Access Compliance Report
Public Rights-of-Way
(Curb Ramps)

Intersection ID: N/A | **Main Street:** SMITHFIELD_RD | **Cross Street:** AVONCLIFF_DR | **Location:** NE

ADA ID: A3B0F5187CEA | **Ramp Type:** PerpDiag | **Initial Pass/Fail:** Fail | **Overall Compliance:** No | **Severity Score:** 12.5

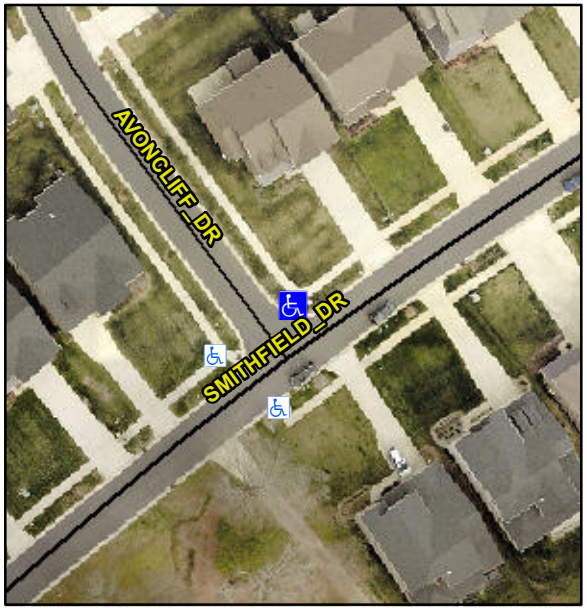
Not Found, R304.5.3

Compliance	Description	Data	Compliance	Description	Data
N/A	Ramp Length (in)	97.0	Yes	Ramp Slope (%)	6.8
Yes	Ramp Width (in)	48.0	No	Ramp XSlope (%)	5.1
N/A	Flare Type LT	N/A	N/A	Flare Type RT	N/A
N/A	Flare Slope LT (%)	N/A	N/A	Flare Slope RT (%)	N/A
N/A	Flare Traversable LT?	N/A	N/A	Flare Traversable RT?	N/A
N/A	Landing Length (in)	N/A	N/A	DWS Provided?	N/A
N/A	Landing Width (in)	N/A	N/A	DWS Contrast?	N/A
N/A	Landing Slope (%)	N/A	N/A	DWS Length (in)	N/A
N/A	Landing X Slope (%)	N/A	N/A	DWS Full Width?	N/A
N/A	Landing Curb? (Y/N)	N/A	N/A	DWS Offset (in)	N/A
N/A	Shared Landing?	N/A			
N/A	Gutter Ponding?	N/A	N/A	Gutter Slope (%)	N/A
N/A	Gutter Lip Ht (in)	N/A	N/A	Gutter X Slope (%)	N/A
N/A	Painted X Walk1?	No	N/A	Painted X Walk2?	No
	X Walk 1 Direction	To W		X Walk 2 Direction	To S
N/A	X Walk 1 Width (in)	N/A	N/A	X Walk 2 Width (in)	N/A
	X Walk 1 Slope (%)	2.5		X Walk 2 Slope (%)	7.0
	X Walk 1 X Slope (%)	4.8		X Walk 2 X Slope (%)	1.6

Remove & Replace Curb Ramp With Two New Directional Ramps or Equivalent.
